**SEAS DEADLINE 6 RESPONSE to APPLICANTS's SUBMISSIONS**  
**SINCE DEADLINE 5, ISH3, Action Points and ExQ3**  
**LANDSCAPE & VISUAL and CULTURAL HERITAGE**

**PINS Ref:** EN020026  
**DEADLINE 6:** APRIL 13, 2026

# EN020026 SEA LINK DCO – DL6: RESPONSE BY NICHOLAS BRIDGES

## ZTV ANALYSIS – IP ref FA62B0DA

**Figure 8. Sea Link 2023-10 PEIR Volume 3 Part 2 Chapter 2 Figures A, page 10:**  
 REPRESENTATIVE VIEWPOINT LOCATIONS AND SCREENED ZONE OF THEORETICAL VISIBILITY - PROPOSED PROJECT WITH CO-LOCATION CONVERTER STATIONS AND SPR FRISTON SUBSTATION (OPTION 3)

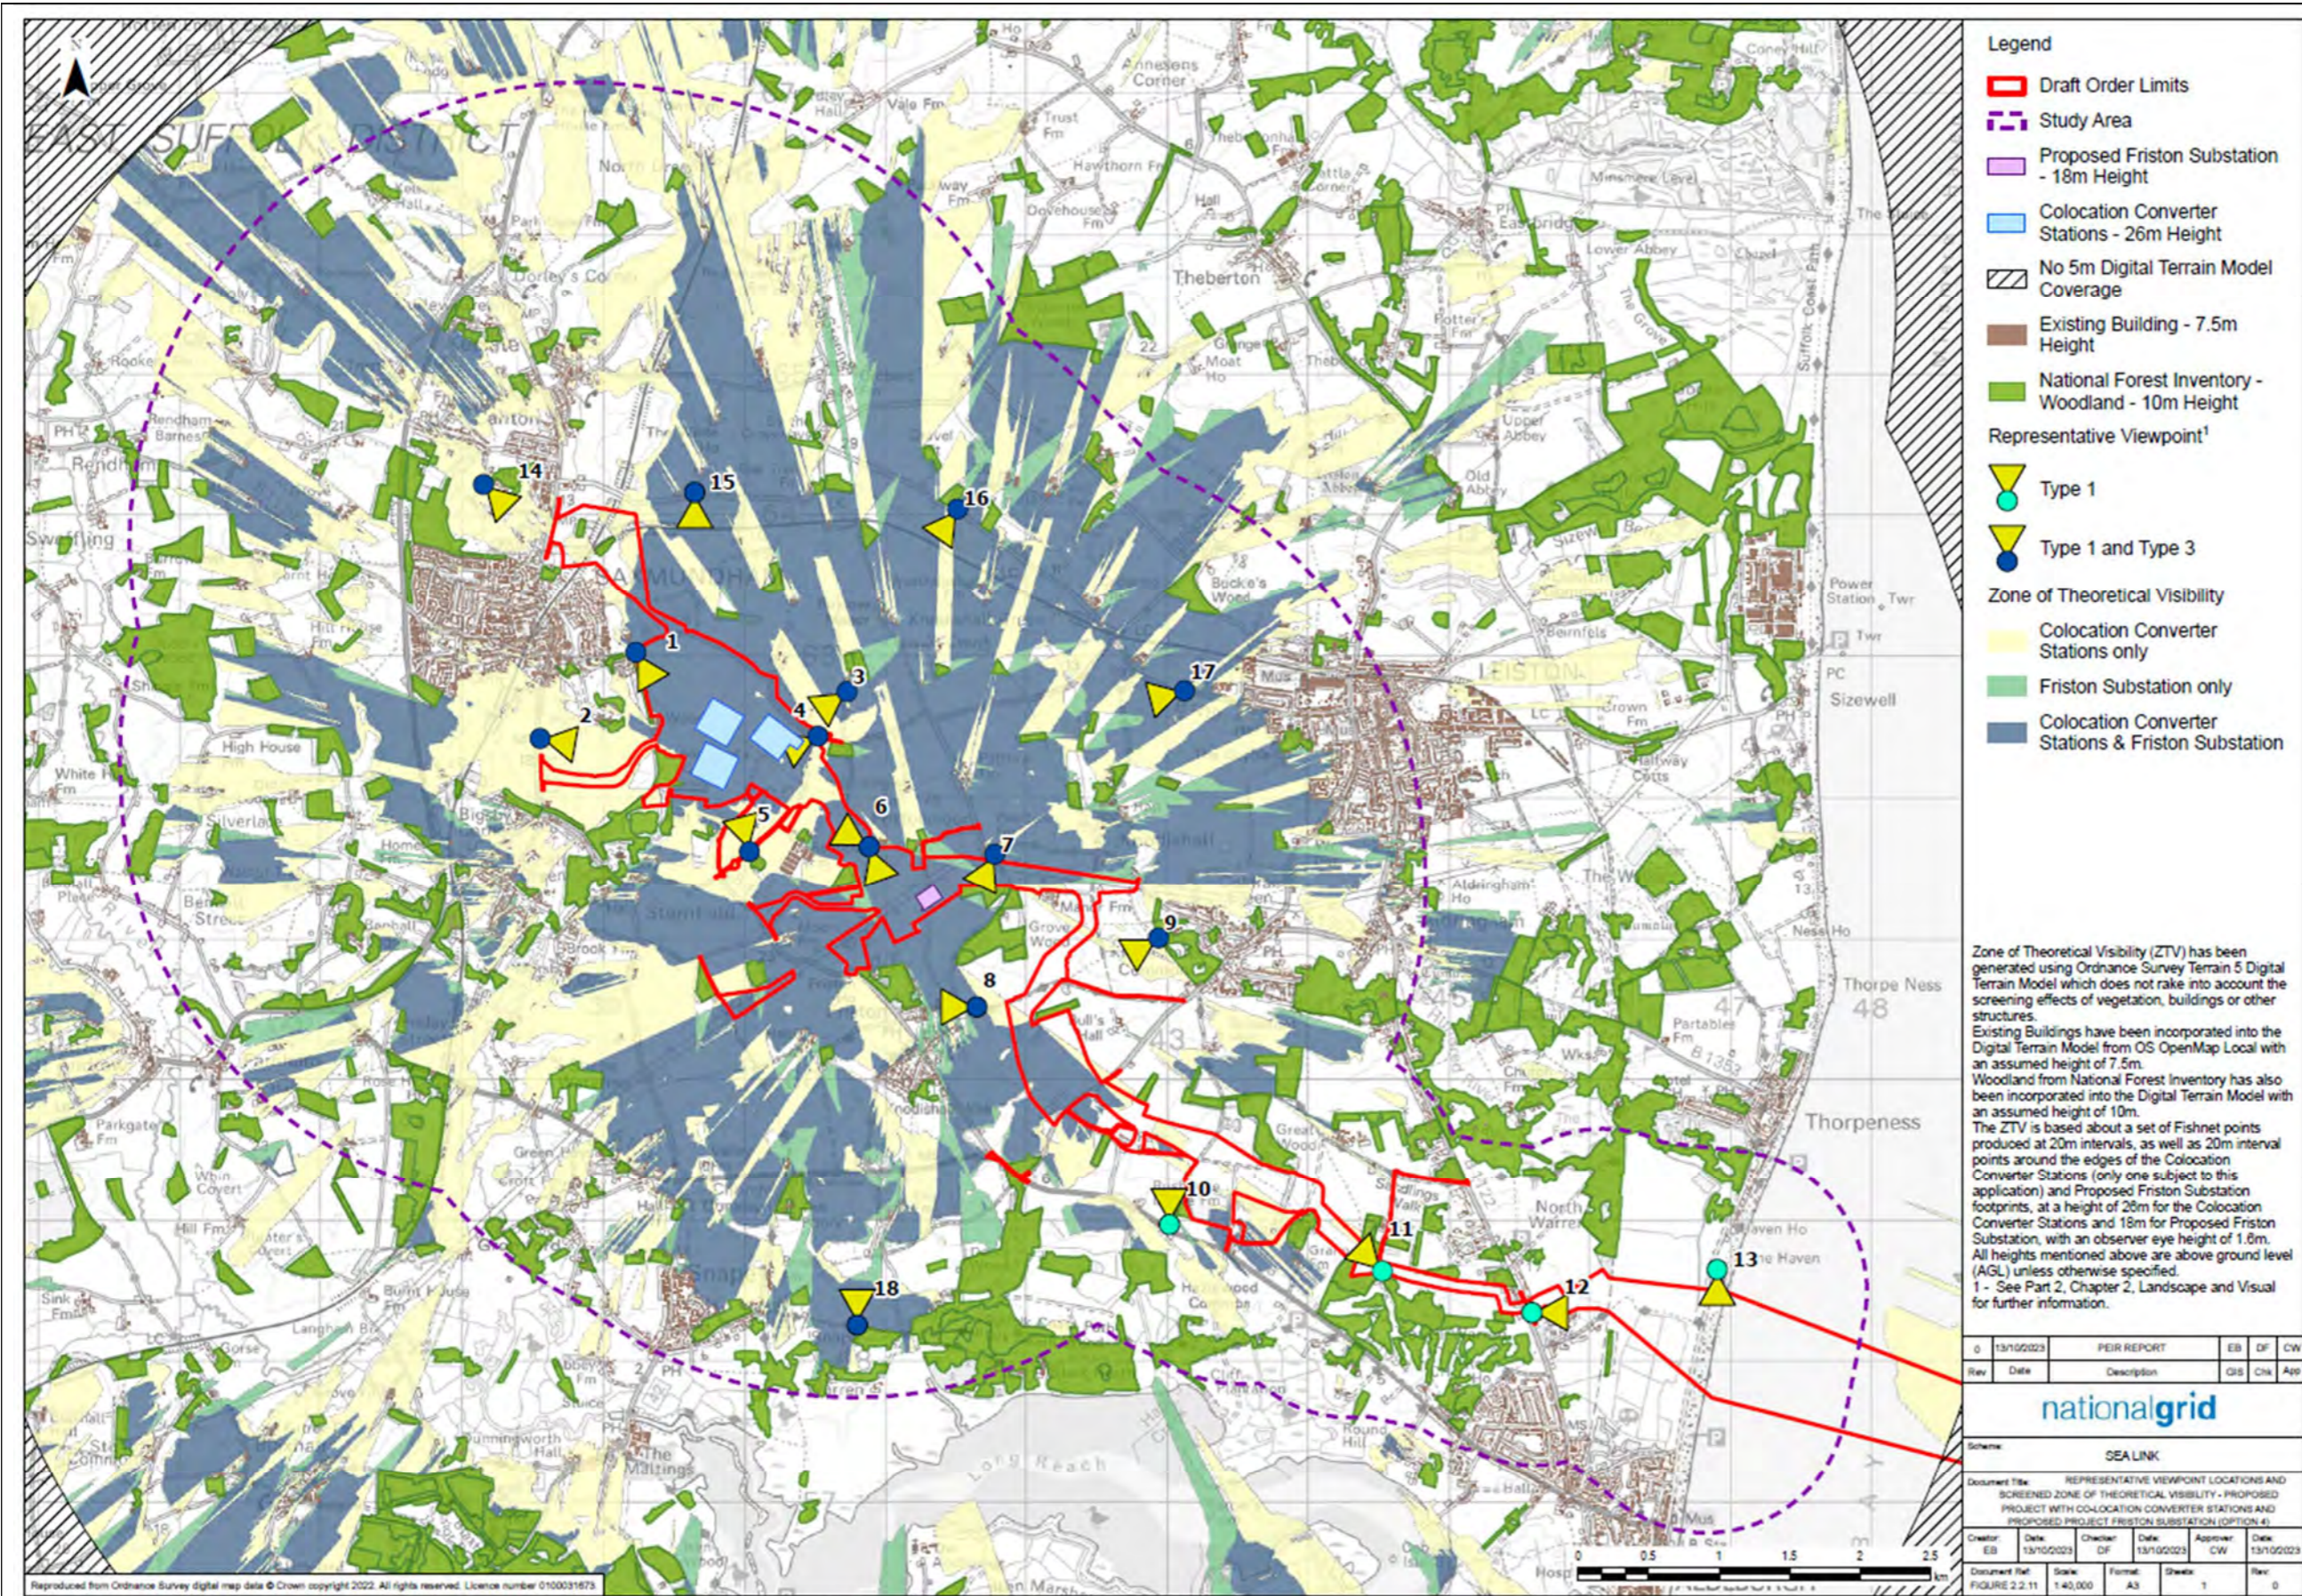
2.9. The ZTVs of the two Friston projects and Sea Link's PEIR have a similar pattern of visibility around their projects (see **Figures 1 to 11** below). Sea Link includes the National Grid substation at Friston which each of EA1N and EA2 also included. All Projects were modelled using OS contours, woodland and buildings at a generic height. Observer heights were a little higher for EA1N and EA2. The two Friston substations used the same parameter model as Sea Link.

2.11. The **first question** is: why are the PEIR and DCO plans so completely different? Were the heights in the model changed? Were the shadowing criteria altered? Which is correct? If the DCO is correct, were the EA1N and EA2 ZTVs incorrect? These are simple technical points which can be explained easily.

2.12. The **second question** is: With the majority of the ZTV plans showing extensive visibility of both Friston substations (18m above ground level) and Sea Link (26m above ground level) on the south side of the Alde estuary, at high tide mark and on the 20m ridge above, why was the information on these plans not followed or commented upon?

**Figure 13. Sea Link EN020026-000339-6.4.2.1 ES Figures Suffolk Landscape and Visual Part 1 of 7, page 15**  
 REPRESENTATIVE VIEWPOINT LOCATIONS AND SCREENED ZONE OF THEORETICAL VISIBILITY - SEA LINK AND FRISTON SCENARIO 2

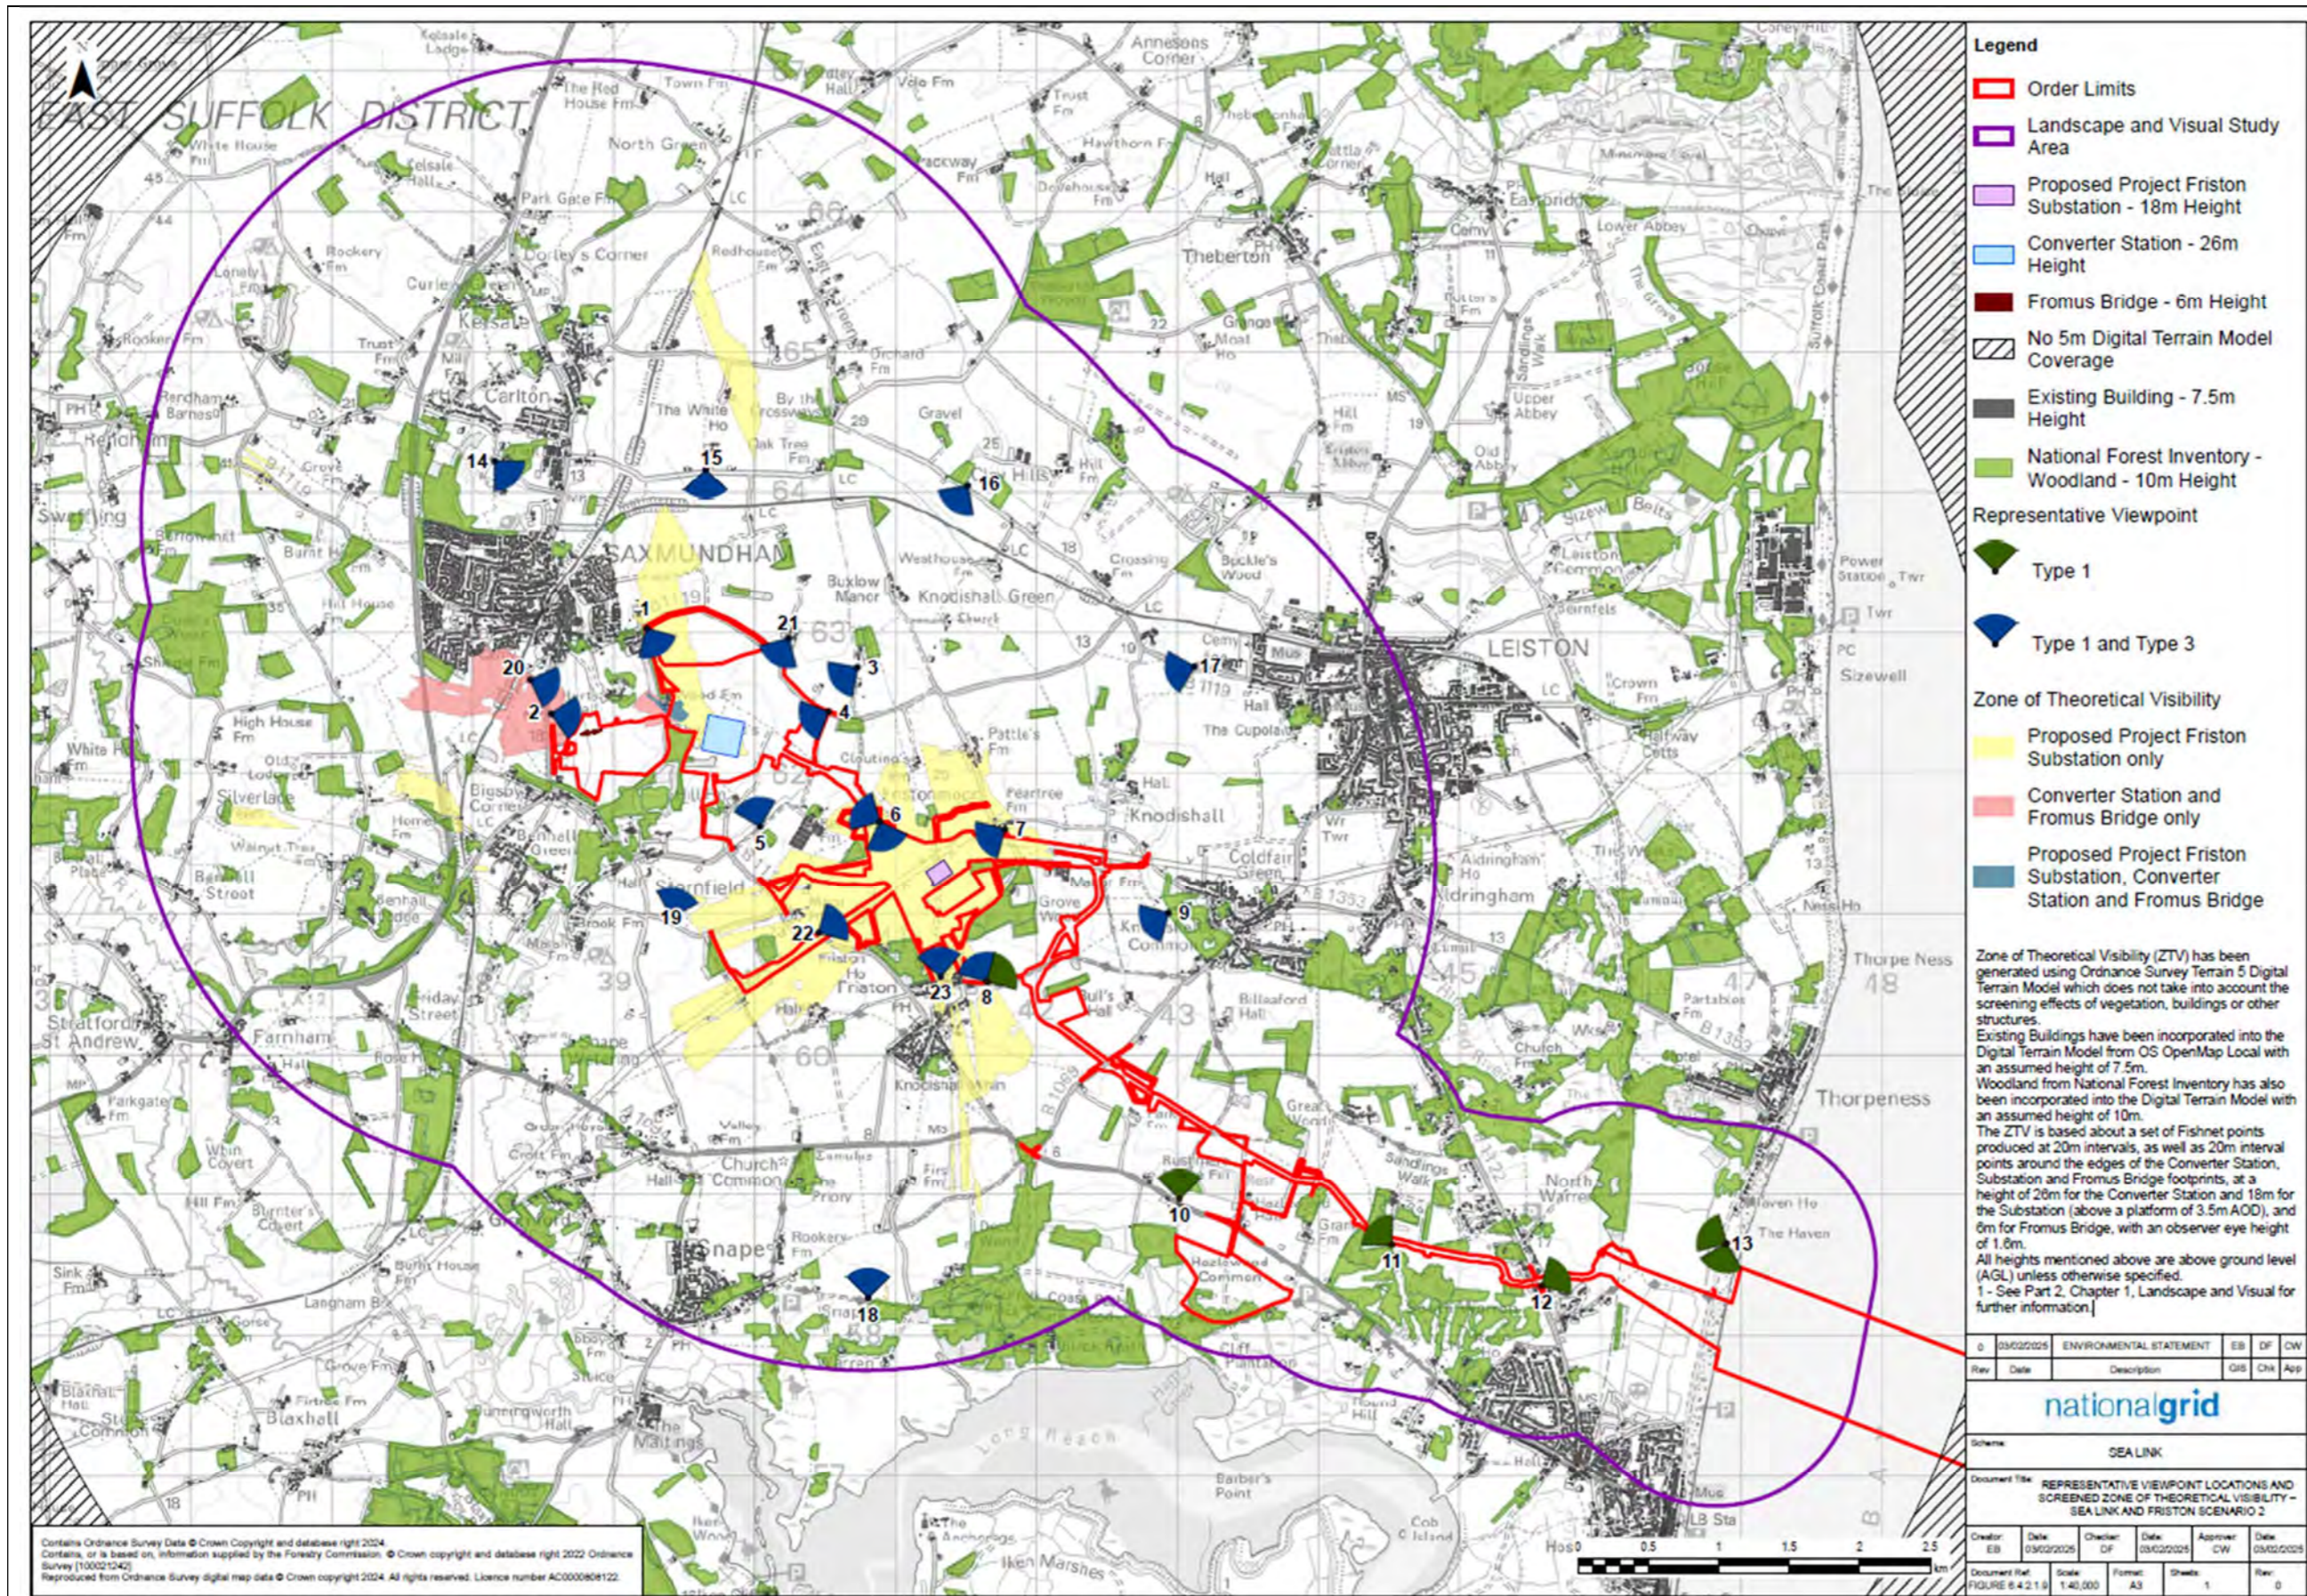
2.10. The 'shadow' patterns illustrate the 'shading' effects of woodland and buildings. The ZTV plans of the same proposed volumetric parameters (**Figures 12 to 17** below) show far less visibility than its PEIR ZTV plans. The accompanying textual details of the model's constraints are exactly the same (see the schedule below).
